PRODUCT CHANGE NOTIFICATION

Bourns® 1250A and 1420A Series UL 1449 Surge Protective Device (SPD) Type Upgrade

SPD2508

CHANGE DESCRIPTION - BEFORE

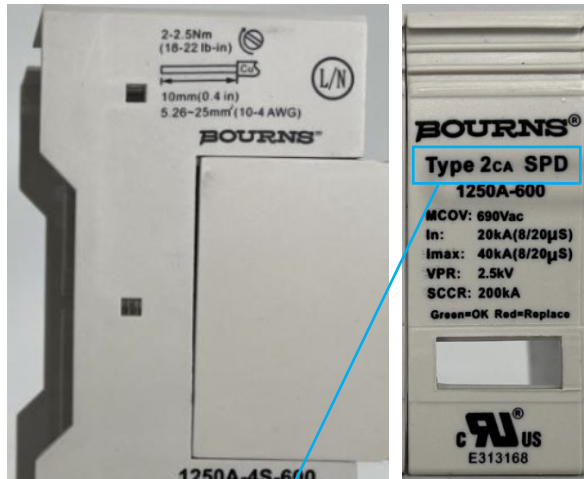
The printed marking on the module of the affected part numbers will change from “Type 2CA” to “Type 1CA”.

Type 2CA SPD

CHANGE DESCRIPTION - AFTER

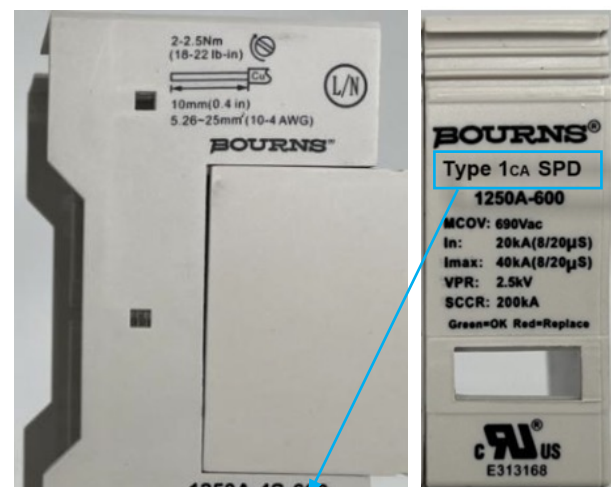
Type 1CA SPD
